PROJECT NAME: Miraflor Apartments (MSPM 19-008)

APPROVAL SOUGHT: Request for Major Site Plan modification approval to construct multifamily residential development consisting of 58 rental apartments within five (5), two/three-story structures with associated residential improvements on 3.87 acres zoned IPUD.

EXHIBIT "C"
CONDITIONS OF APPROVAL

Project Name: Miraflor Apartments
 File number: MSPM 19-008
 Reference: 3rd review plans identified as a Major Site Plan Modification with a February 11, 2020 Planning and Zoning Department date stamp marking.

PLANTING-PLAN

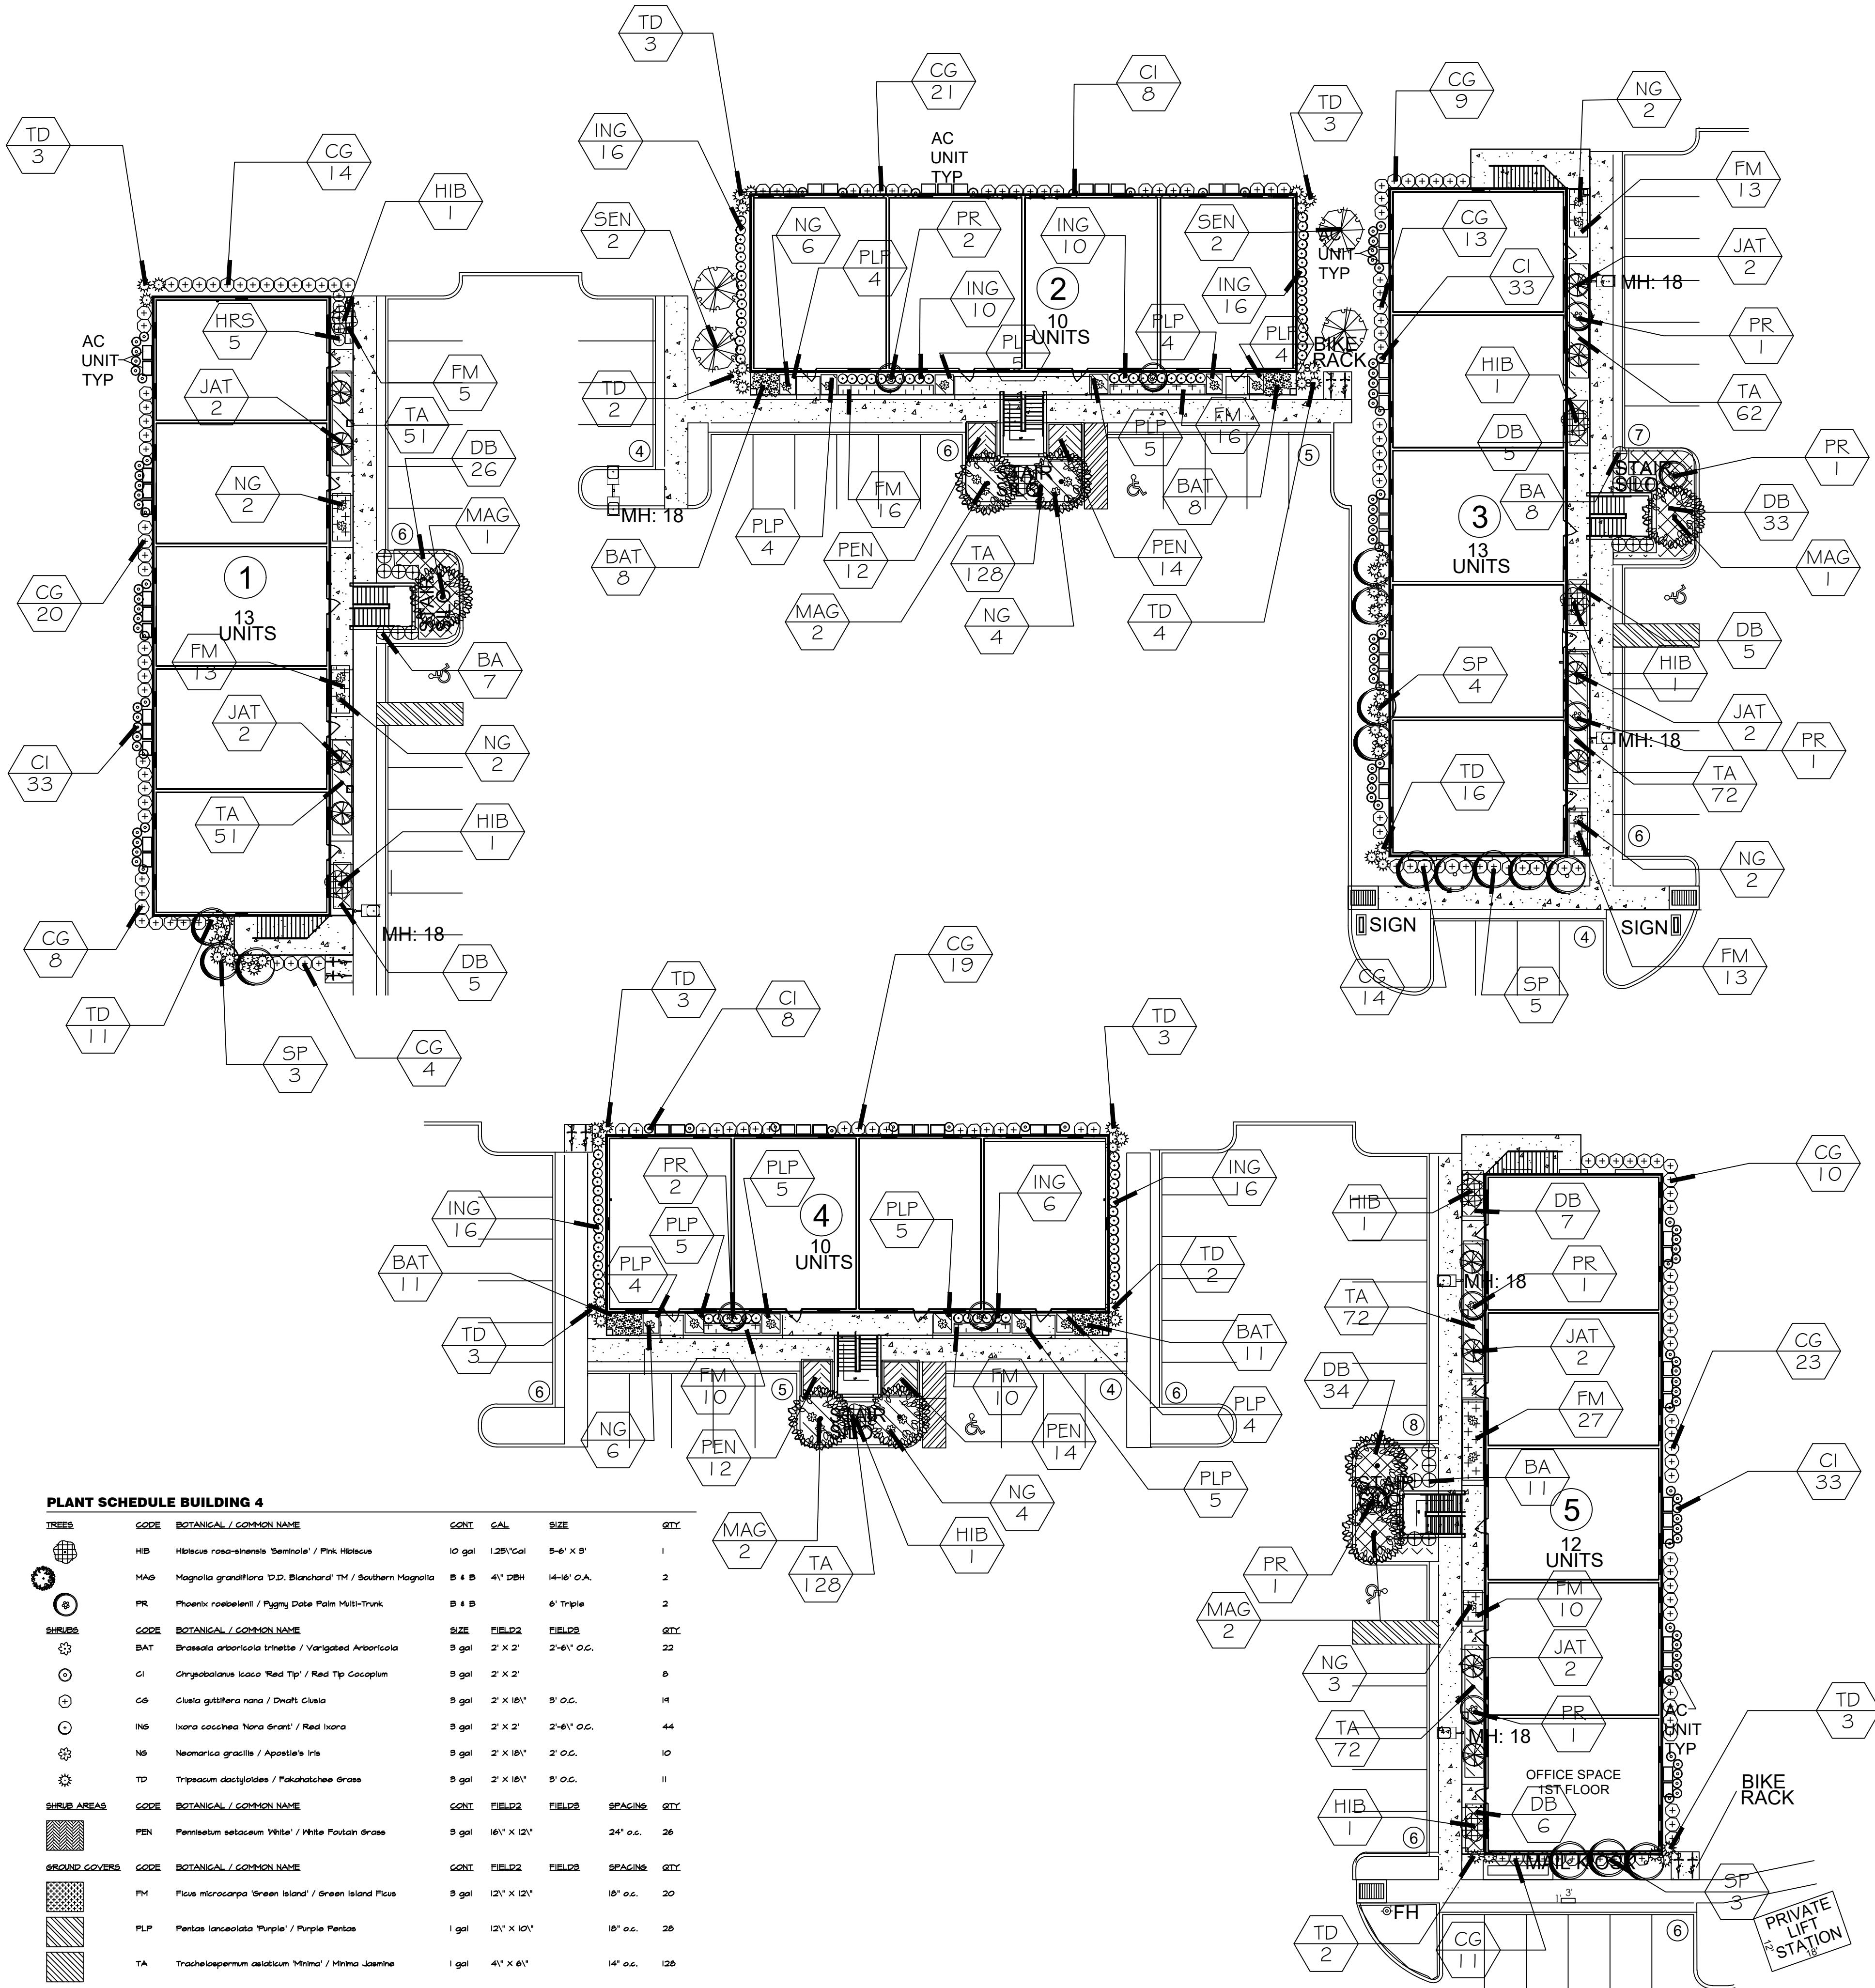
17. Revise plant list to include the following requirements: a minimum 4-inch tree caliper for all required trees (except for signature trees); a minimum of 6 different canopy tree species, clusters of 3 Sabal Palms count as one (1) canopy tree; shrubs to be a minimum of 24" in height and spread.	√

18. At time of permitting, revise landscape plan to comply with FPL Right Tree/Right Place requirements for all trees located in or adjacent to utility easements.	√

19. At time of permitting revise landscape plan to provide on all large landscape islands a large canopy tree, not palms, and to provide required City signature trees on each side of entrance drive.	√

20. The foundation trees required around each apartment building are required to be installed at one-half the height of the building. Indicate foundation landscaping (trees and shrubs) on landscape plan and note on plant list the number of trees that comply with this requirement. Update typical building landscape plans and plant lists accordingly, and provide a detailed building elevation or rendering with the landscaping depicted at time of planting.	√

21. An irrigation plan is required to be submitted and approved prior to the issuance of a permit for this project. Revise landscape plan to note proposed method of irrigation and location of well if proposed.	√
